Dear Dr. McLean,

I hereby submit the revised version of my GChron manuscript on “An algorithm for U-Pb geochronology by secondary ion mass spectrometry”. I have already addressed the reviewers’ major comments in my response on the GChron discussion page. In this cover letter, I will go over their specific comments.

Pieter Vermeesch

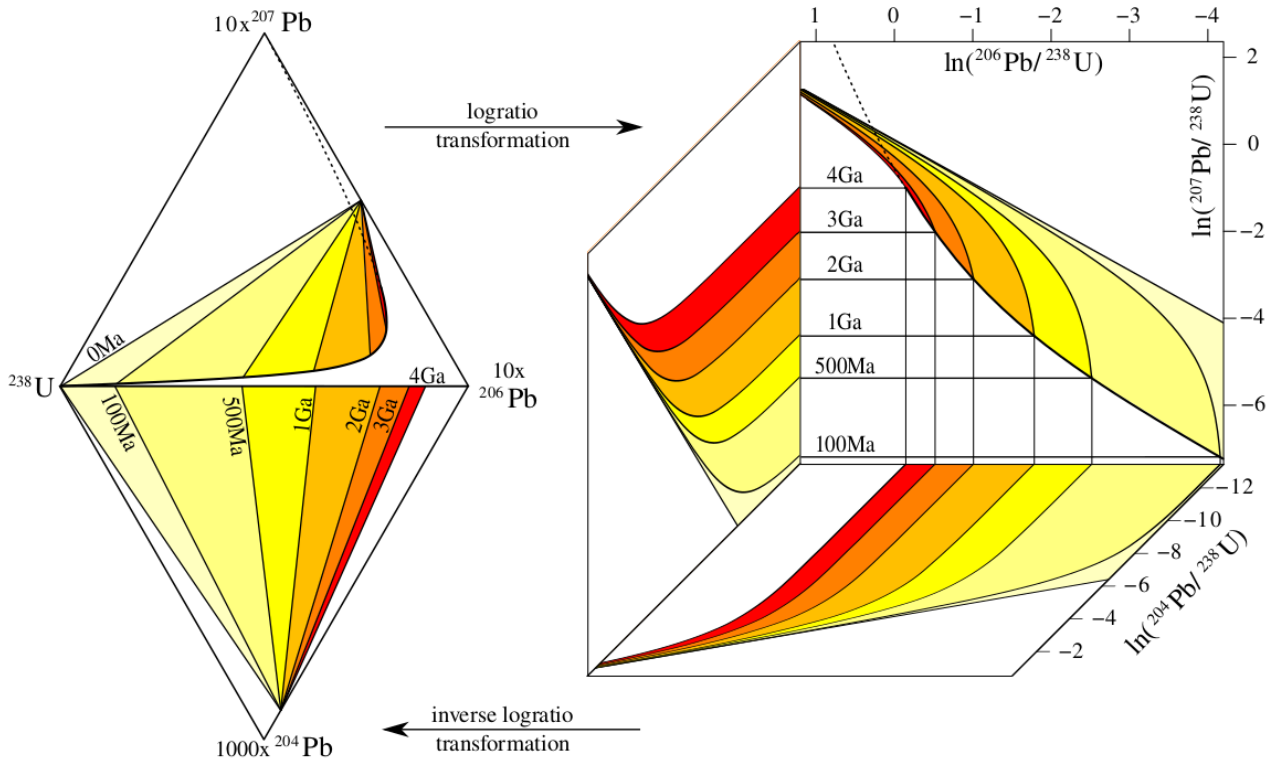
To make this figure even more informative, add a third ternary field to the left-hand plot with 206Pb-238U-207Pb, so that it is more analogous to the back face of the plot on the right and so that a concordia line will be shown on a ternary plot.

I haven't added a third panel, but I did replace the 207Pb-204Pb-238U panel with the 206Pb-238U-207Pb diagram. I also added the concordia line as a thick black line (from 0 to 4Ga) and a dotted line (>4Ga), as mentioned in the revised caption:

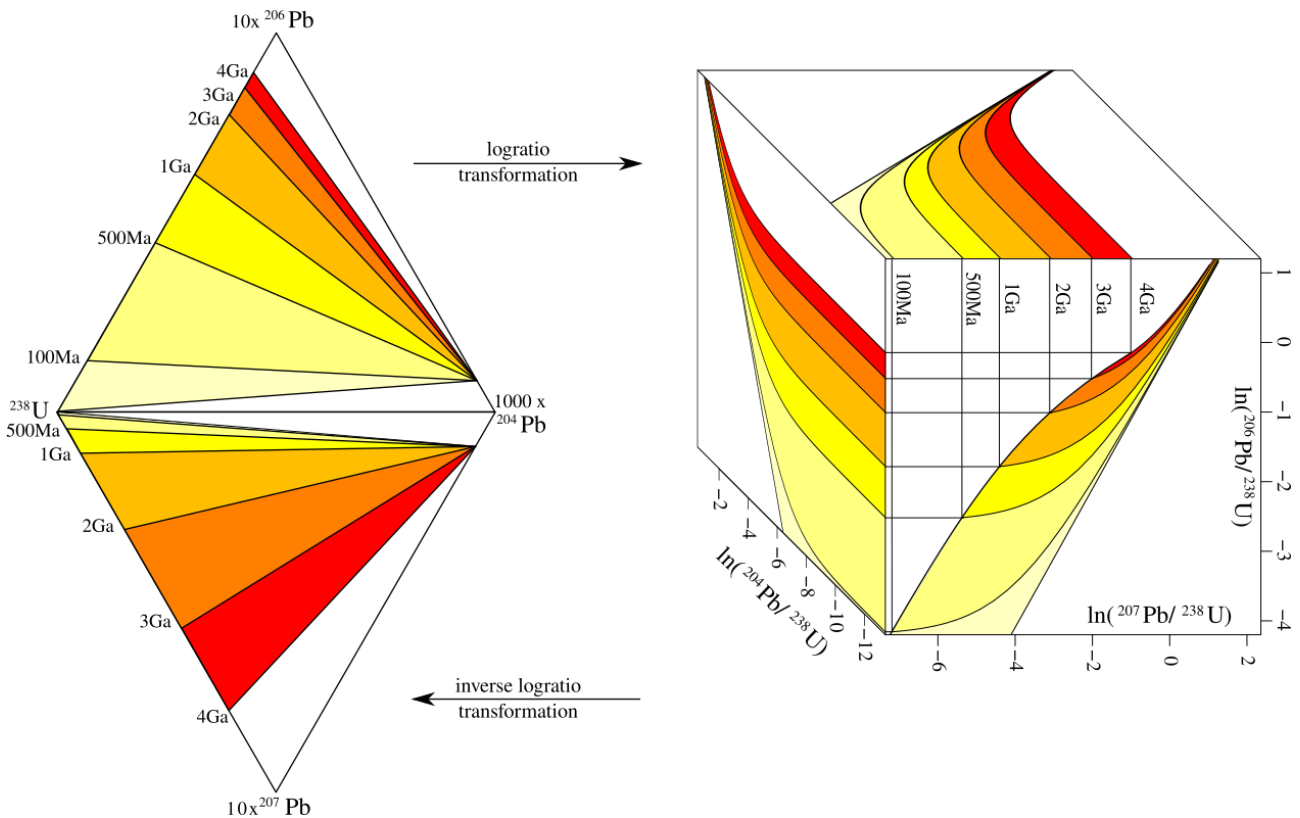
Also, the right-hand plot has its back panel coordinate axes reversed from the (Wetherill) concordia convention that has 206/238 on the y-axis and 207/235 on the x-axis.

This is true, but rotating the figure 90 degrees clockwise produces a plot that looks uglier (in my opinion), as shows one project above the back panel rather than under it:

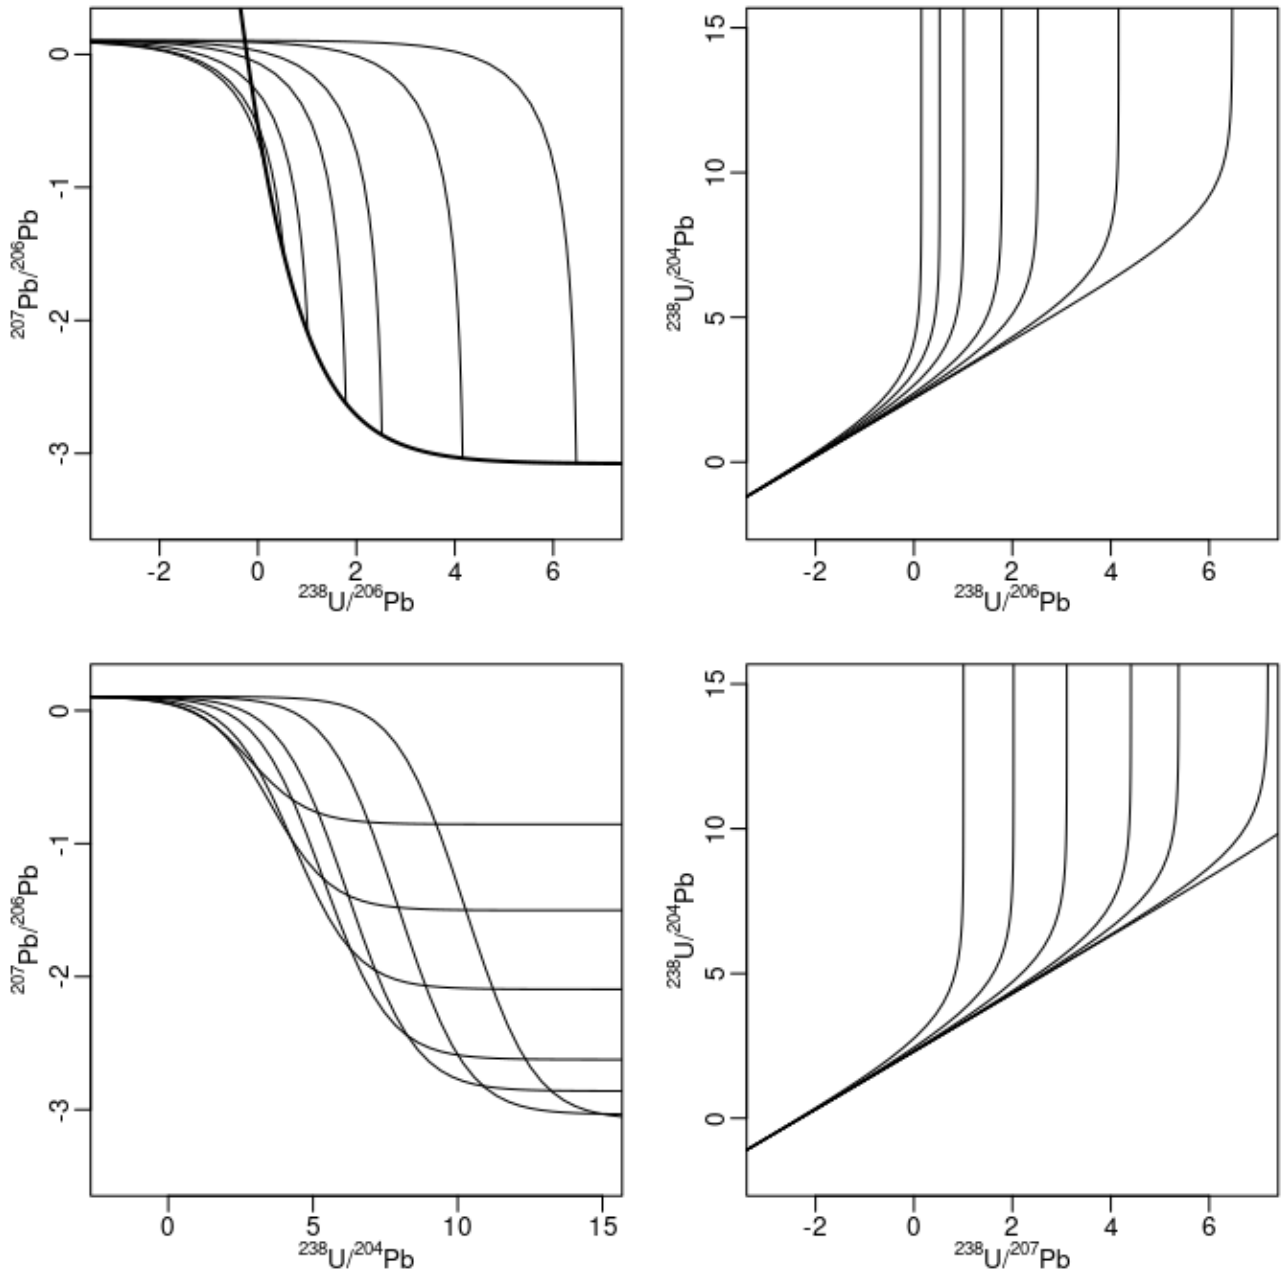
An even better idea might be to plot $^{207}\text{Pb}/^{206}\text{Pb}$ vs. $^{238}\text{U}/^{206}\text{Pb}$ in log-ratios on the right, as the Tera-Wasserburg concordia plot is more widely used in the SIMS U-Pb community.

I have also tried this, but the problem here is that the $^{207}\text{Pb}/^{206}\text{Pb}$ vs. $^{238}\text{U}/^{204}\text{Pb}$ plot contains lines that cross over and cannot easily be colour coded. It would, of course, be possible to omit the $^{207}\text{Pb}/^{206}\text{Pb}$ vs. $^{238}\text{U}/^{204}\text{Pb}$ plot, but then it is no longer possible to show the logratio plot as a 3D image:

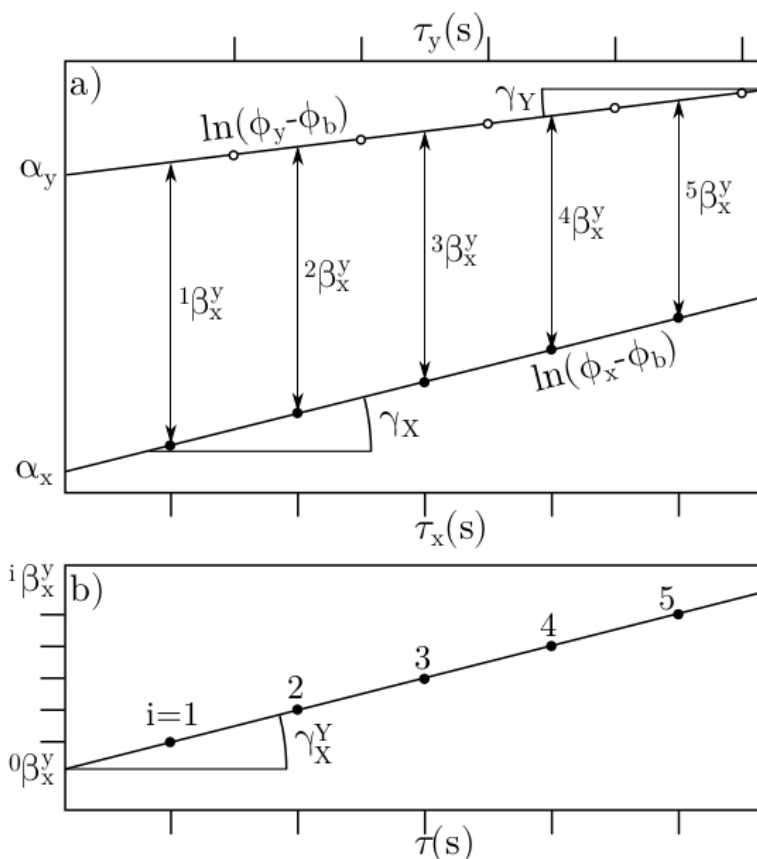
Equation 19 -- I suggest the multiply-indexed parameters be explained/illustrated in a concise figure, with or without accompanying data.

All my attempts to explain the procedures graphically produced figures that are more complicated than the equations. Here is one attempt to capture Equations 18 (panel a) and 19/20 (panel b). I think that it will confuse rather than enlighten the reader:

I did add the following clarification about the relationship between the equations of Sections 9 and 10: “Note that $\gamma_X^Y=0$ if $X=Y$ and, if the sensitivity drift of the data is smooth and closely follows the trends defined by Equations 96 and 17, then $\beta_x^y \approx \alpha_y - \alpha_x$ and $\gamma^Y_X \approx \gamma_Y - \gamma_X$.”
